MICKEY'S PLACE SUBDIVISION

APPLICATION NUMBER 18 DATE July 15, 2004

REQUEST Subdivision

MICKEY'S PLACE SUBDIVISION

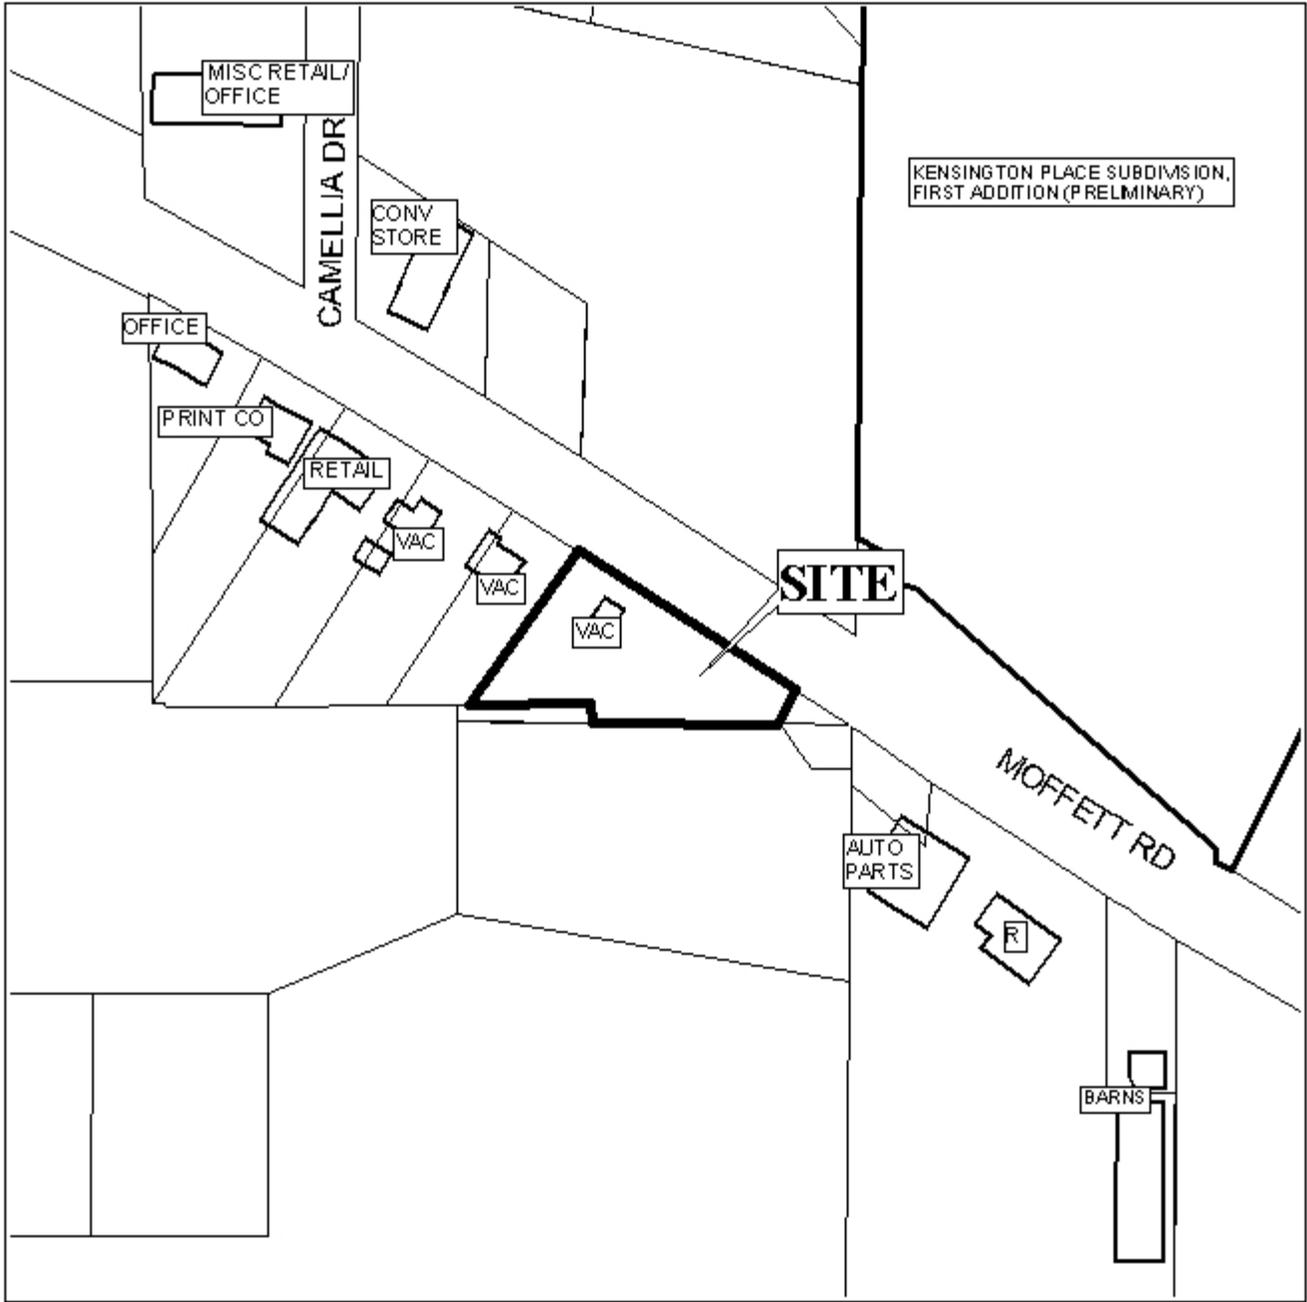
The site fronts Moffett Road, a planned major street, which has an existing right-of-way of 85 feet; the Major Street Plan requires a 100-foot right-of-way. Therefore, the dedication of any necessary right-of-way to provide 50-feet from the centerline of Moffett Road, should be required. This is a commercial site; thus dedication is for a one-lot subdivision. Additionally, as a means of access management, the placement of a note on the final plat stating that the number, location and design of all curb cuts are to be approved by ALDOT and County Engineering, should be required.

The 25-foot minimum building setback line is not shown but would be required on the final plat.

There is a discrepancy in the legal description of the site and an area apparently acquired by the State. The legal description of area acquired by the State does not plot to coincide with the area reflected on the plat. This discrepancy should be addressed prior to final approval of the plat.

The plat meets the minimum requirements of the Subdivision Regulations and is recommended for Tentative Approval subject to the following conditions: 1) submission of documentation to clear the discrepancy of the legal description to the satisfaction of Urban Development and County Engineering staffs; 2) the dedication of adequate right-of-way to provide 50-feet from the centerline of Moffett Road; 3) the placement of a note on the final plat stating that the number, location and design of all curb cuts are to be approved by ALDOT and County Engineering; 4) the placement of a note on the final plat stating that any lots which are developed commercially and adjoin residentially developed property must provide a buffer, in compliance with Section V.A.7. of the Subdivision Regulations; and 5) the placement of the 25-foot minimum setback line on the final plat.
